TRANS/WP.29/GRSG/2001/14
13 July 2001

PROPOSAL FOR DRAFT AMENDMENTS TO REGULATION No. 66
(Strength of superstructure)

Transmitted by the Expert from Hungary

Insert a new annex 5, to read:

Figure A1.

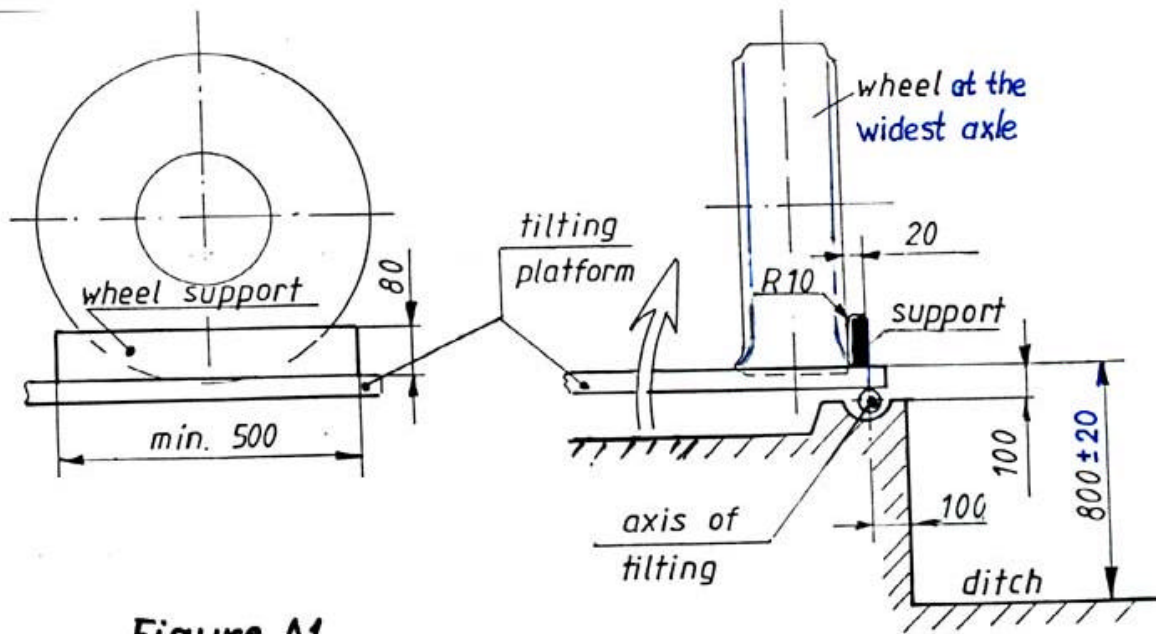
- 1.2. The height difference between the horizontal lower plane of the ditch (see figure A1.) and the plane of the tilting platform on which the bus is standing, shall be 800 ± 20 mm

- 1.3. The tilting platform, related to the ditch, shall be placed as follows (see figure A1.):
 - 1.3.1. the axis of its rotation is max 100 mm from the vertical wall of the ditch;

- 1.3.2. the axis of the rotation is max 100 mm below the plane of the horizontal tilting platform;
 - 1.4. Wheel supports shall be applied at the wheels being close to the axis of rotation against sliding of the vehicle sideways when tilting it. The main considerations of wheel supports shall be (see figure A1).

Figure A2.

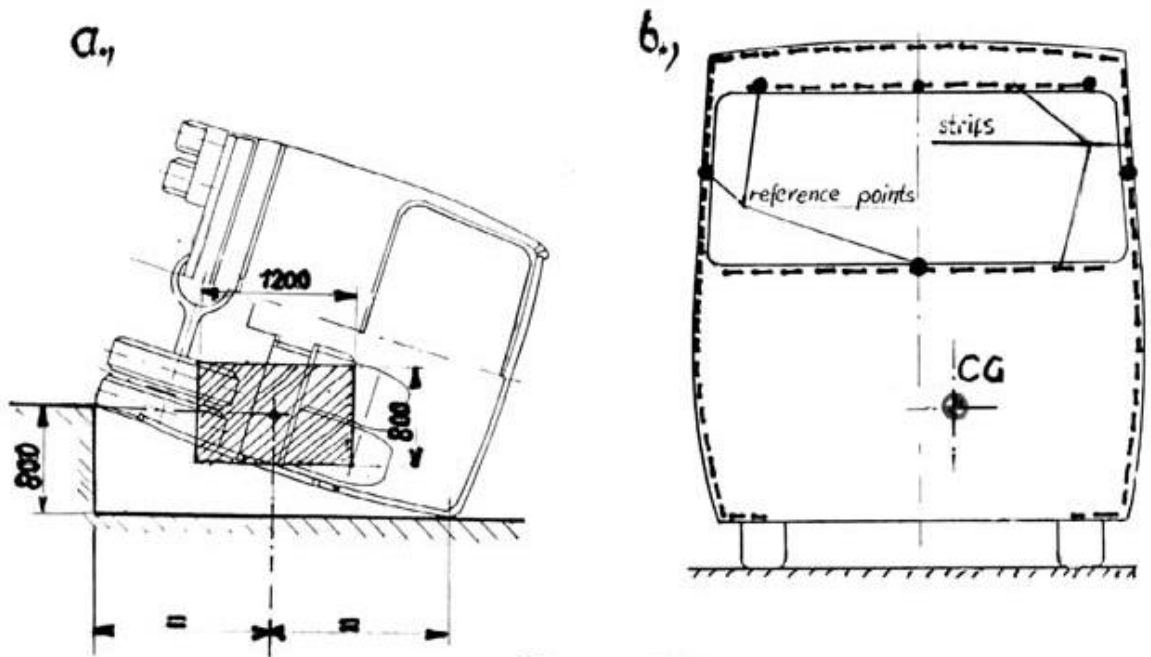
- far enough from the front and rear wall of the vehicle to avoid the distortion of the picture (to produce measurable picture)
 - in the range of the shaded area shown on figure A2/a.

- 3.4.2. at least the position of the centre of gravity and the contour of the superstructure (see figure A2/b) is recommended to be marked by stripes and bands to ensure correct measurements on the pictures.

Figure A/A1.

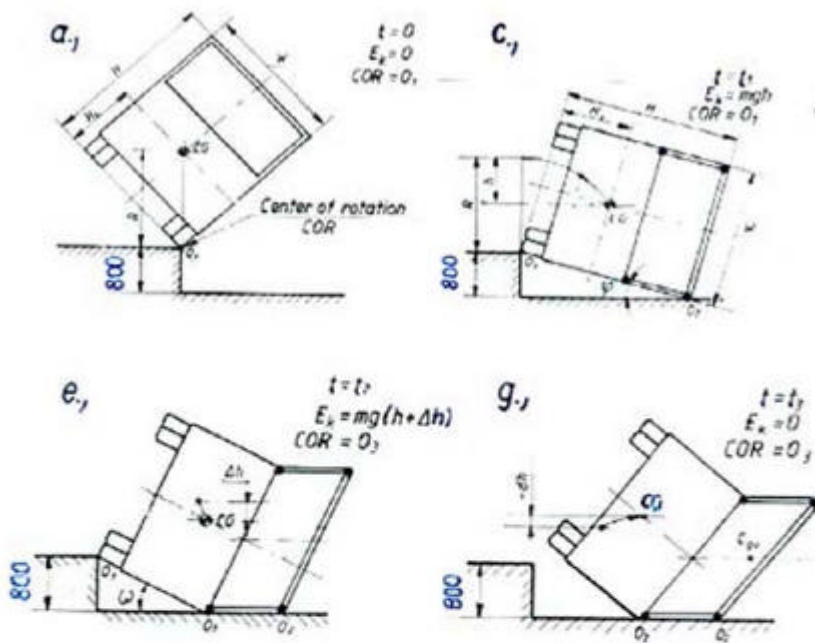
2. The following main stages of the rollover process may be determined and distinguished
 - (a) Starting position ($t=0$).
Unstable situation, the vehicle is standing on its one-side wheels, no motion. The centre of gravity is in the highest position which represents a certain potential energy (see figure A/A1-a).

- (c) Cantrail collision with the ground (t_1).
The vehicle hits the ground, new dynamic supporting (reaction) force is built up alongside the cantrail (O_2) where local deformation occurs, and the ground also absorbs certain energy. The motion of the roof (upper part of the vehicle) is slowed down (see figure A/A1-c).

- (e) Waistrail collision with the ground (t_2).
If the superstructure is not so strong that the structural deformation stops in the previous stage, the waistrail also hits the ground, where some local deformations may occur. The upper part of the vehicle is almost stopped in motion. A new dynamic supporting force is created at the waistrail (O_3) while the supporting force at (O_1) is decreasing to zero (see figure A/A1-e).

- (g) Critical structural deformation (t_3).
The mass and reaction forces cannot overcome the resistance of plastic hinges anymore, the plastic hinges stop working. This is the moment of the critical (maximum) deformation containing both elastic and plastic deformations. This is the moment in which the requirement of the unharmed residual space shall be checked and proved. This is also an unstable position of the vehicle in respect of its motion (see figure A/A1-g).

Figure A/A2.

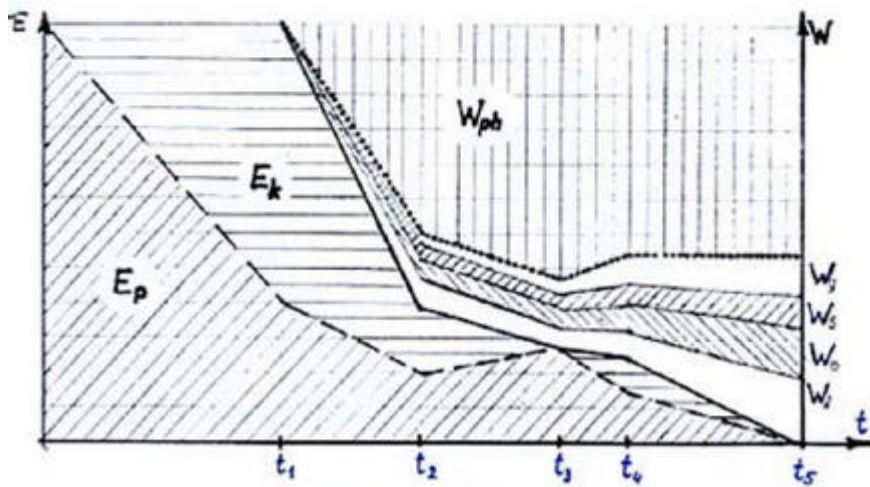
3. The energy balance of the rollover process is shown on figure A/A2. This is also a time dependent process, and studying it at least the following components shall be considered:
